[Docket No. NHTSA-2014-0088]

#### Visual-Manual NHTSA Driver Distraction Guidelines for In-Vehicle Electronic Devices

**ACTION:** Notice of Federal guidelines; clarifications.

Figure 1. Plane FA Showing Lines 1 and 2 and the 2D Downward Viewing Angle

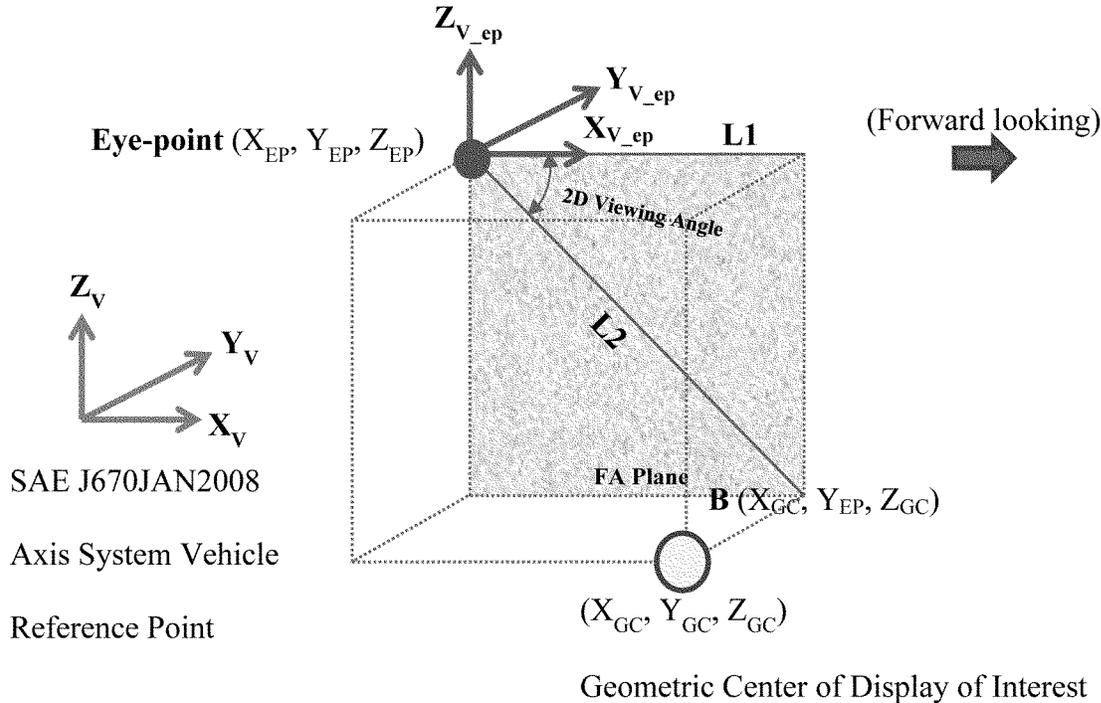
In the April 2013 Final Guidelines Notice, NHTSA committed to clarifying the process of determining the downward viewing angle. In particular, the agency noted that several commenters had requested notations regarding the measurement of eye height to ground in grid coordinates for 2D and SAE curb ground line coordinates in 3D. NHTSA interpreted those comments as requesting figures similar to those found in the Alliance of Automobile Manufacturers' distraction guidelines (Alliance Guidelines).<sup>3</sup> The figures in the Alliance Guidelines are intended to clarify coordinates and measurements used when calculating a display's downward viewing angle, and the agency indicated that it would add similar figures to the Phase 1 Guidelines. Accordingly, the Phase 1 Guidelines are being amended to reference an additional SAE standard in Subsection III.B and the sections related to downward viewing angle have been revised and illustrative diagrams have been added. Finally, a more detailed explanation of the figures and mathematical calculations of the angles have been added in order to make the figures easier to understand.

The revised text of Subsections V.C.7 and V.C.8 read as follows:

b. Create a fore-and-aft plane (Plane FA) through the *nominal driver eye point*. Determine the  $(X_{EP}, Y_{EP}, Z_{EP})$  coordinates of the *nominal driver eye point*. Plane FA is parallel to both the  $X_V$  and  $Z_V$  axes and is perpendicular to the  $Y_V$  axis. Since the *nominal driver eye point* is generally not on the *vehicle plane of symmetry*, Plane FA will normally be offset, either to the left or to the right, from the vehicle reference point shown in Figure 1. All points in Plane FA will have the same  $Y_V$  coordinate,  $Y_{EP}$ .

*nominal driver eye point*. Figure 1 shows Plane FA. Line 1 is marked in Figure 1.

f. Generate Line 2. Line 2 is in Plane FA and goes through the *nominal driver eye point* and Point B. Figure 1 also shows Line 2 in Plane FA. Lines 1 and 2 will intersect at the *nominal driver eye point*.

g. Determine the *2D Downward Viewing Angle*. The *2D Downward Viewing Angle* is the angle, measured in Plane FA, from Line 1 to Line 2. Figure 1 also shows the *2D Downward Viewing Angle*.

Figure 2. Plane EP-GC Showing Lines 3 and 4 and the 3D Downward Viewing Angle

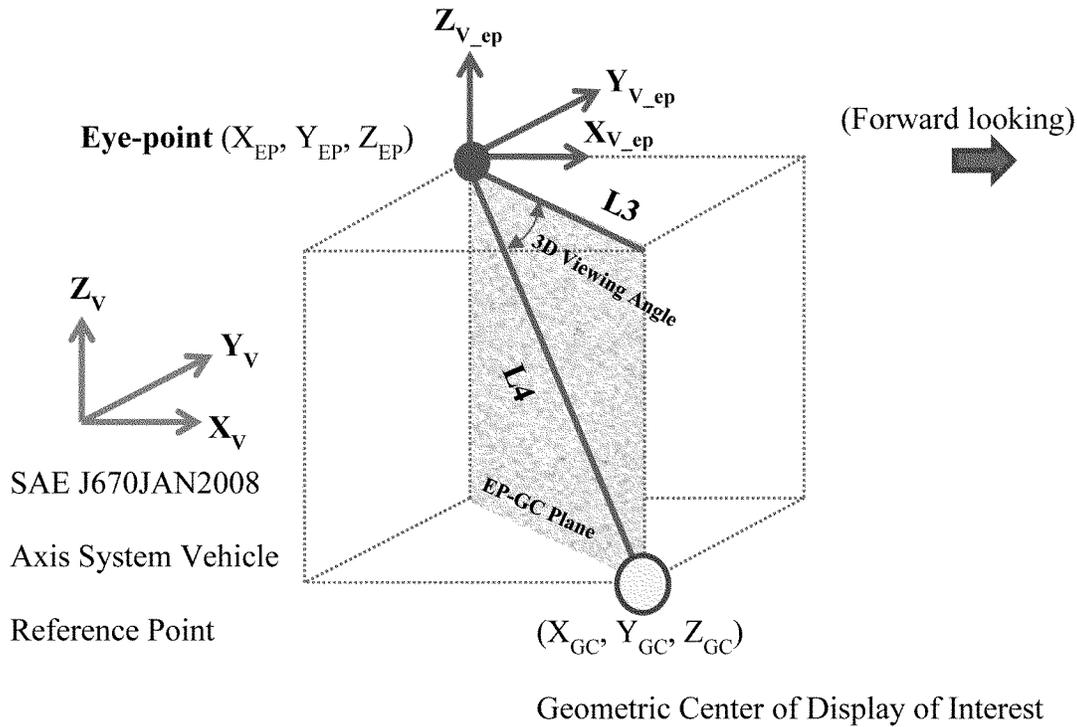
geometric center of the display of interest. Figure 2 illustrates Line 3 in Plane EP-GC.

and intersects with Line 3 at the *nominal driver eye point*. Figure 2 also illustrates Line 4 in Plane EP-GC.

d. Determine the *3D Downward Viewing Angle*. The *3D Downward Viewing Angle* is the angle, measured in Plane EP-GC, from Line 3 to Line 4. Figure 2 also shows the *3D Downward Viewing Angle*.
